TI_2311: Component adaptation fan motor for SelfCookingCenter XS, CombiMaster Plus XS & iCombi 6-2/3

SelfCookingCenter XS, CombiMaster Plus XS & iCombi 6-2/3

20/03/2023

- Graphical representation of the fan motor being discontinued

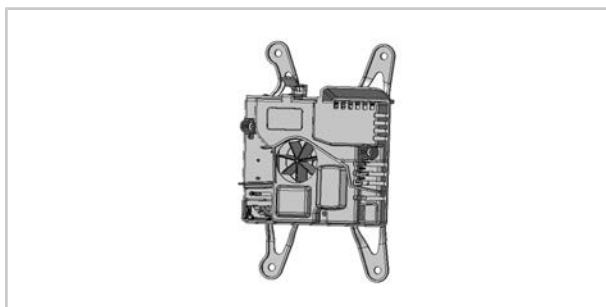
Differences between discontinued and new fan motors

The differences between the fan motors:

- Design (visual)
- Connections (BUS)

Discontinued fan motors

The fan motor being discontinued will be available until 19/3/2023 with article no.: 87.01.374. Control electronics Art. no.: 87.01.376 are available in limited quantities for the fan motor that is being discontinued.

New fan motors

With effect from 20/03/2023, the fan motor with art. no.: 87.01.374 will only be replaced by the new fan motor with art. no.: 87.01.973S in service cases.

With effect from 20/03/2023, the new fan motor with art. no.: 87.01.974S will be fitted ex works and can be purchased as a service part.
